Site visit from 14.09.2011 09:40-12:40 o'clock

Thursday, September 14th – My presence was requested on site for an HPD/DASE inspection. This inspection primarily was to ascertain the physical state of the F line water and waste lines.

Survey Areas: Units 11F, 10F, 9F, 8F, 7F, 6F, 2F, the basement, front entrance and building exterior.

Photo 1 of 5 performance level 040.jpg Date: 14.09.2011 11F ceiling frame

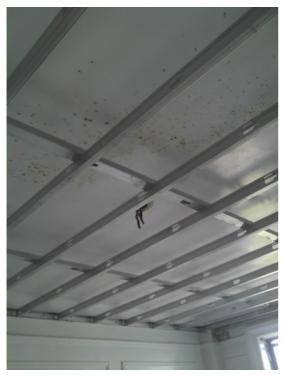
Based upon my conversation with the Architect (Ray Warner), and a review of the plans the contractor is using the incorrect application to install the ceiling frame. A wrought iron material is detailed rather than metal framing. In addition the residents are desirous of keeping the current ceiling aesthetic, therefore I posed the question to the Architect would it be possible to provide wiring molding form the ceiling light to the wall. He advised me that in his opinion the living room and traditional dining room should not have dropped ceilings.
